Appendix 16.2 – Verification Graphs and Detailed Methodology

In response to Clarifications and Additional Assessment Information Requests, this technical note intends to provide clarity on the model verification process and satisfy Clarification (2), presented below.

Figure 3- Marked up map

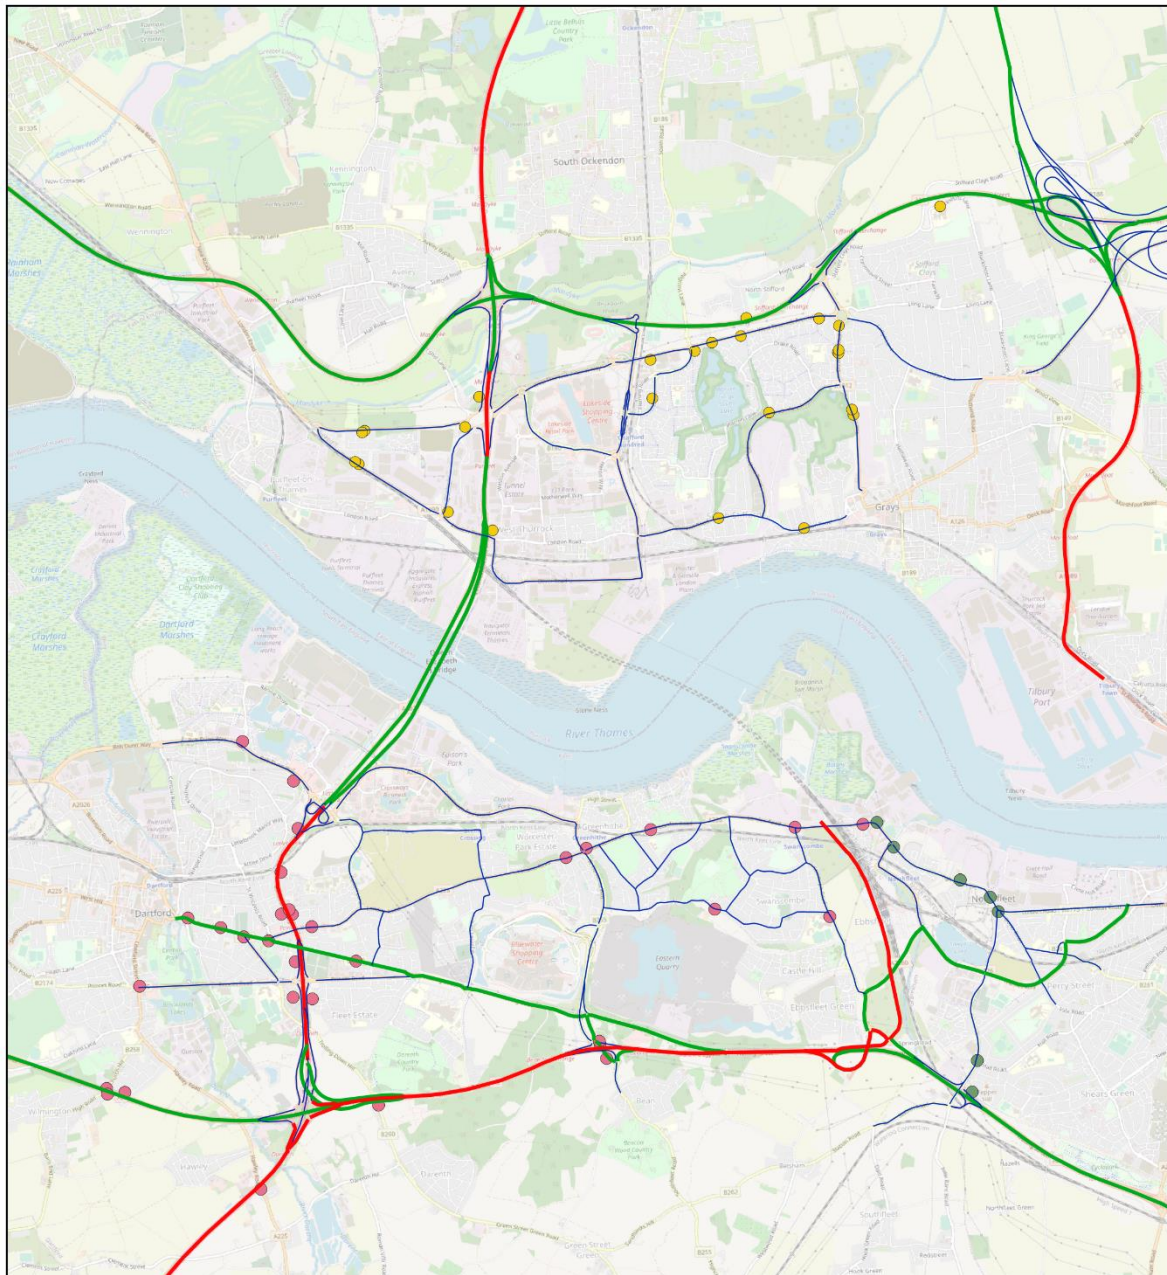
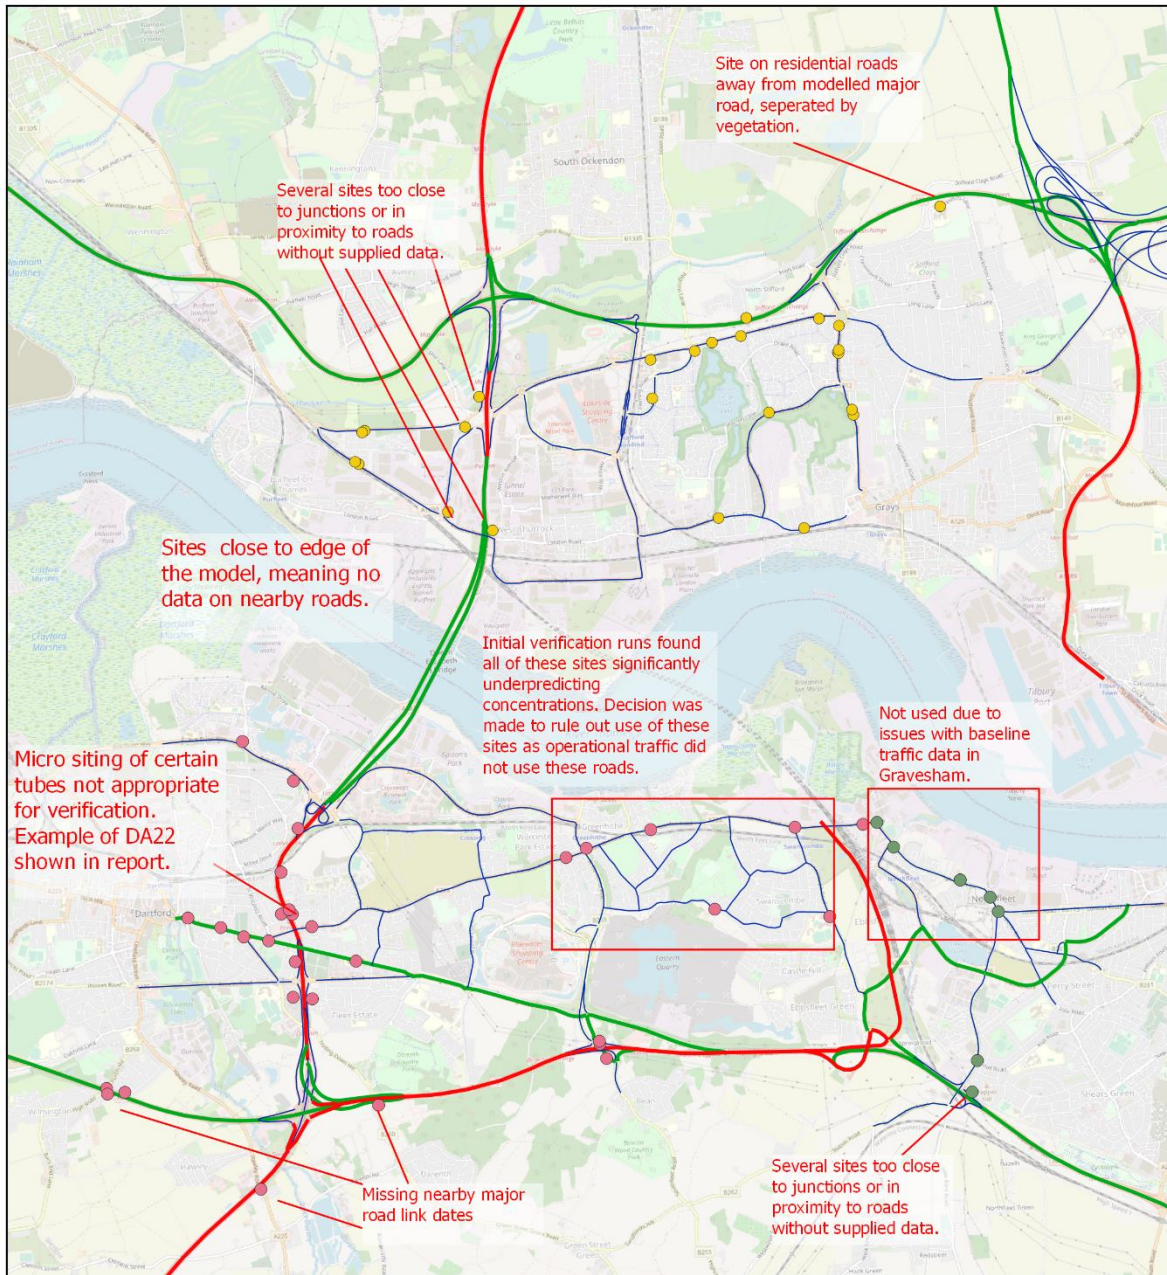
Figure 3 is a marked-up map which provides commentary and high-level justification for ruling out monitoring sites for use as verification site. As well as the reasons presented in the Figure 3, the micro-siting of each tube was reviewed to ensure accuracy against of annual status report and appropriateness for use in the verification. Examples of micro-siting issues for otherwise appropriate sites, and explanation is presented in Figures 5-7.
